Appl. No. 08/828,005
Amdt. Dated Jan. 05, 2004
Reply to Office Action of Nov. 05, 2003
Annotated Sheet Showing Proposed Changes

Fig. 16

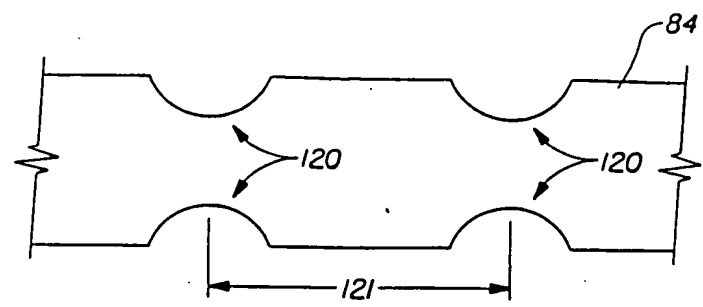
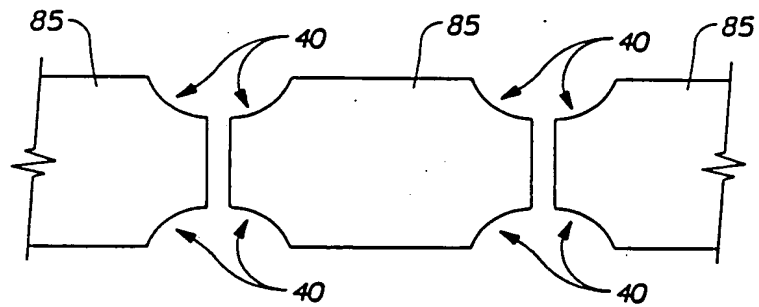
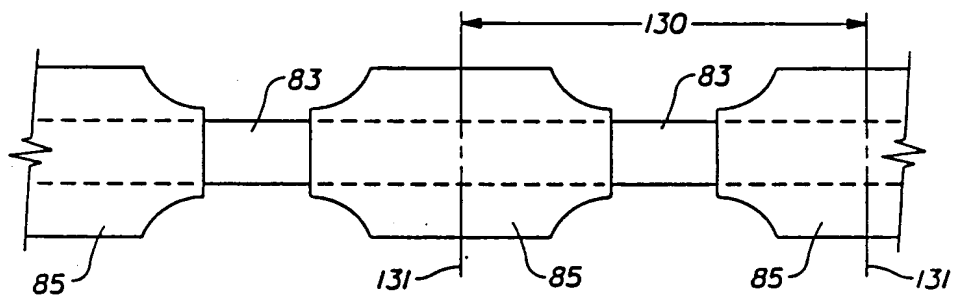
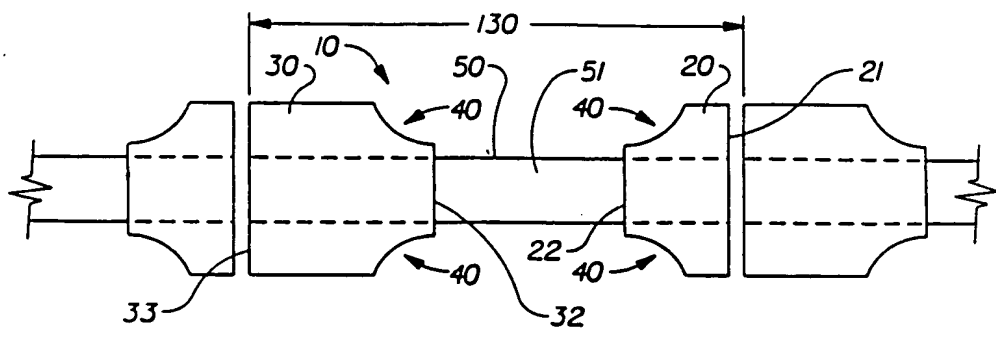
Appl. No. 08/828,005
Amdt. Dated Jan. 05, 2004
Reply to Office Action of Nov. 05, 2003
Annotated Sheet Showing Proposed Changes
